FRANK M. WEAVER & CO., Inc. LANSDALE, PA.	
STRUCTURE SHOP BLDG - D.C. REFORMATORY LORTON - VA.	
CUSTOMER - DISTRICT OF COLUMBIA, COMM.	
DRAWN BY W.M. DATE 6-30-31	
CHECKED BY F.M.S.C. DATE 7/2	
REVISED 6/27/31 H	
S.O. 4029	SH. NO. 1

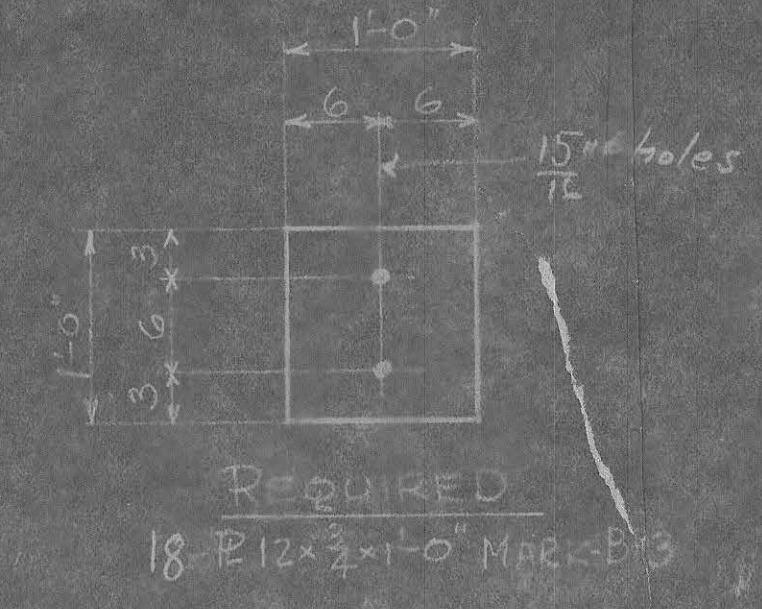
THIS DRAWING APPROVED FOR GENERAL ARRANGEMENT ONLY. ANY DEPARTURE FROM CONTRACT REQUIREMENTS MUST BE APPROVED BY THE ARCHITECT AND WRITTEN APPROVAL OF ARCHITECT IS REQUIRED. CONTRACTOR SHALL BE RESPONSIBLE FOR ALL DIMENSIONS AND CONDITIONS OF BUILDING.
